TRACKED VEHICLES
E 109 Misc Instr No 1

CARRIER, ARMoured, TRACKED, 15-TON (FV 430 SERIES)

TECHNICAL HANDBOOK - MISCELLANEOUS INSTRUCTION

FV.499263 AXLE ARM LH AS DRAWN (ASSY DRG FV499543)
FV.499264 " " RH OPP. HAND (ASSY DRG FV499544)

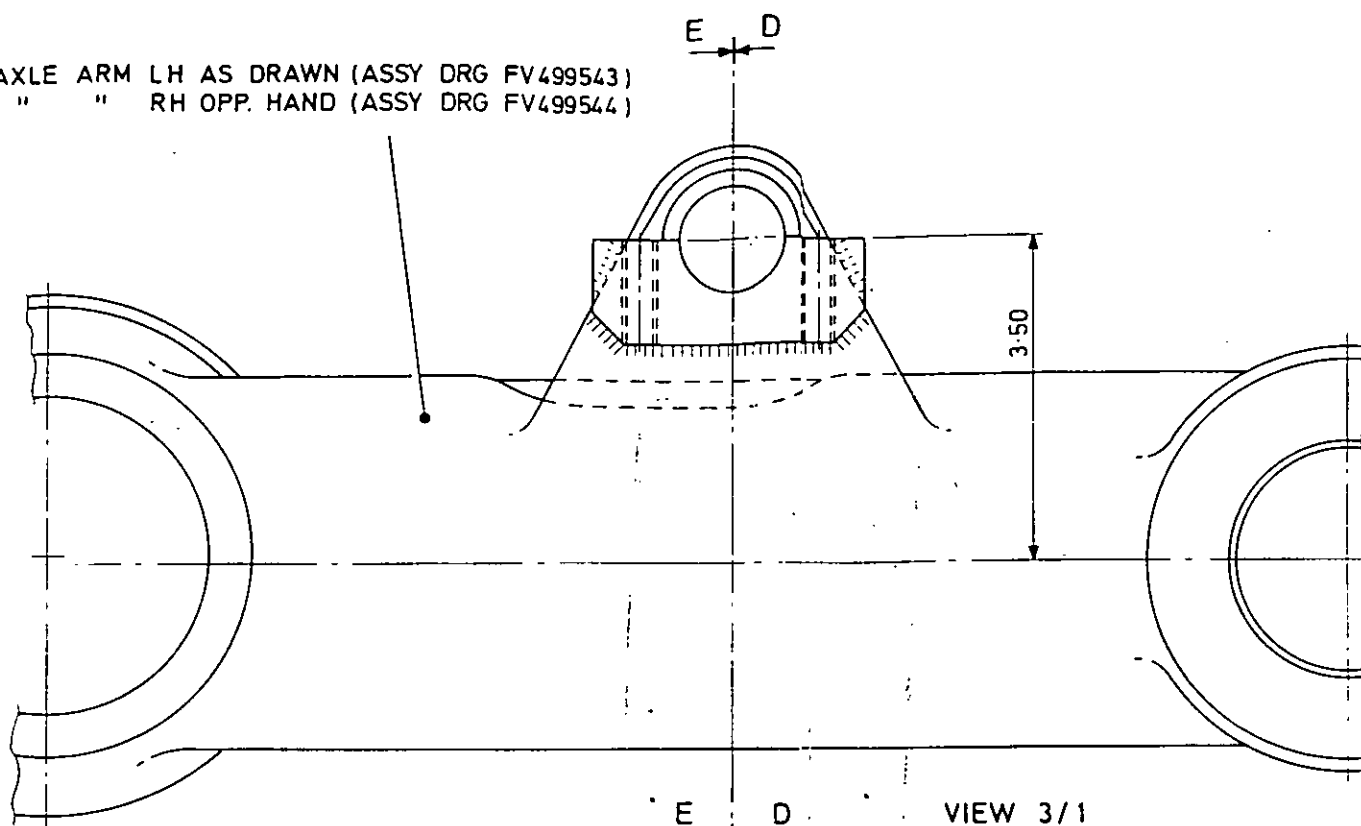
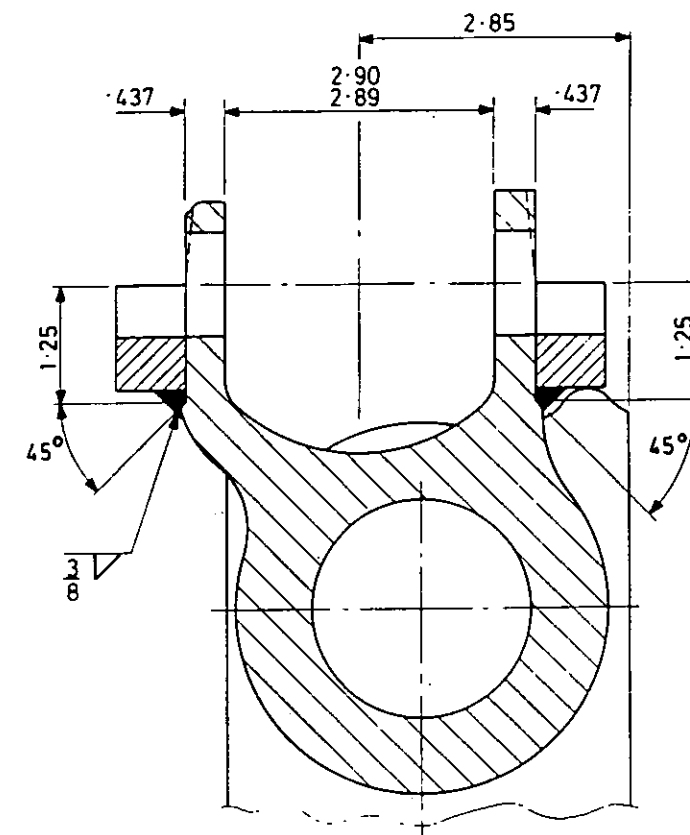
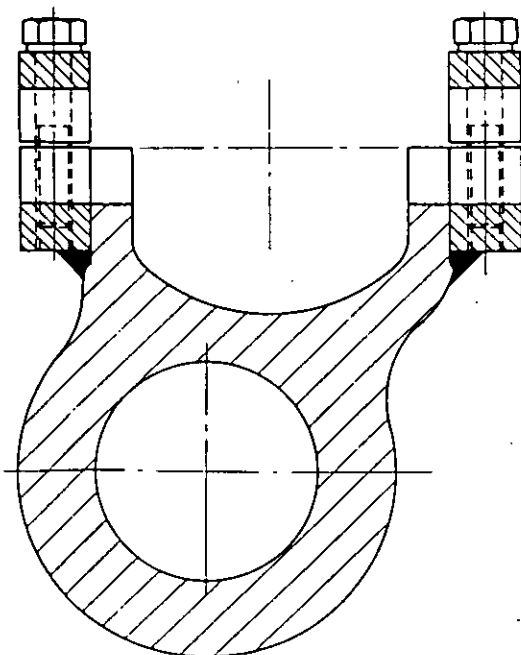
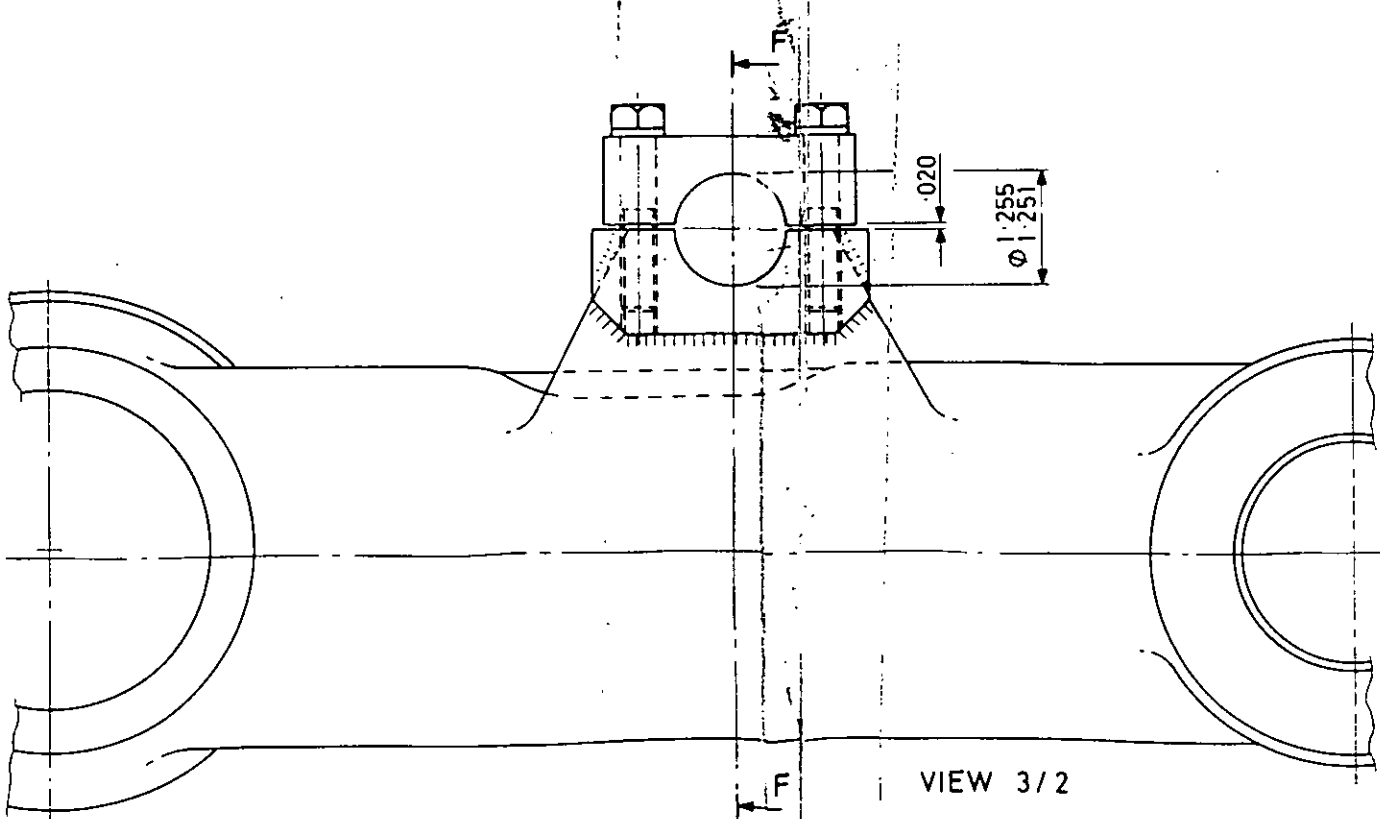
Refer to Fig 3.

9.16 Fill existing 1.1/4 in. - 12 UNF tapped hole with weld, flush with faces of axle arm web.

Fig 1 Front towing eye

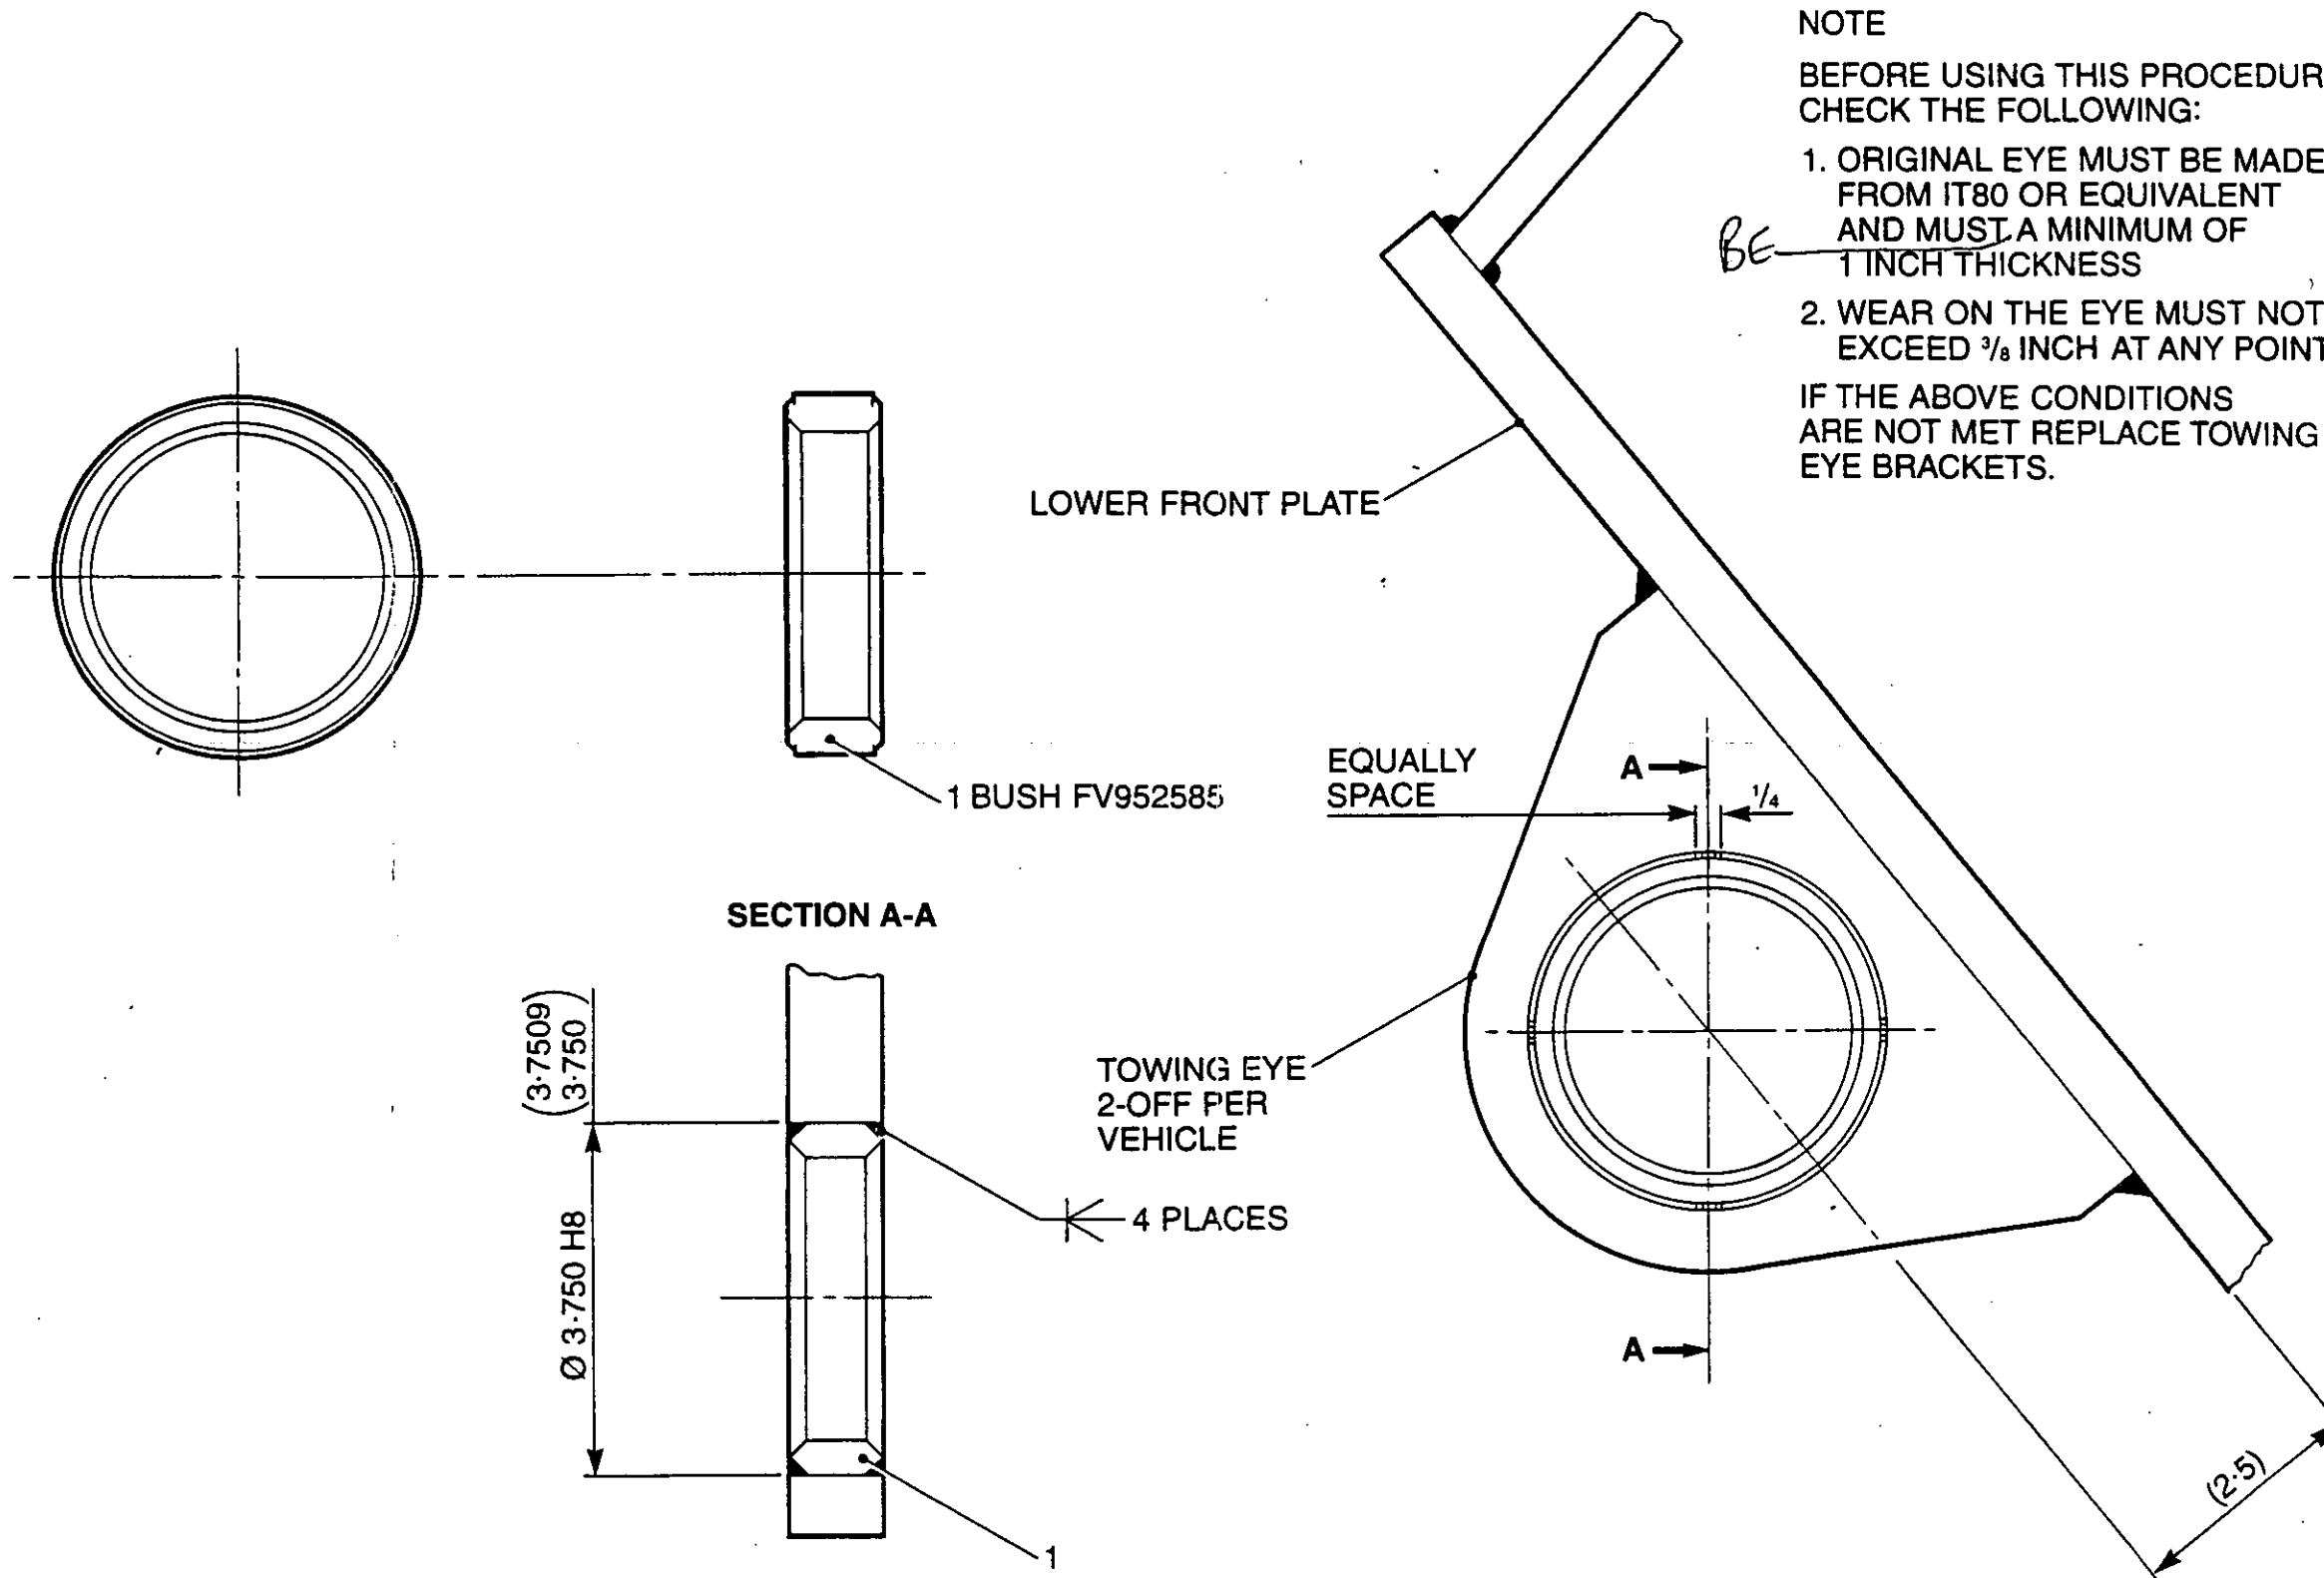
- 9.2 When one, or both front towing eyes are outside repairable limits:
- 9.2.1 Cut off both front towing eyes to within 6 mm of armour plate.
 - 9.2.2 Remove remaining metal by grinding, avoid overheating of armour plate.

1. DRILL OUT TOWING EYE AS SHOWN
2. ASSEMBLE BUSH - DETAIL 1
3. TACK WELD TO SECURE
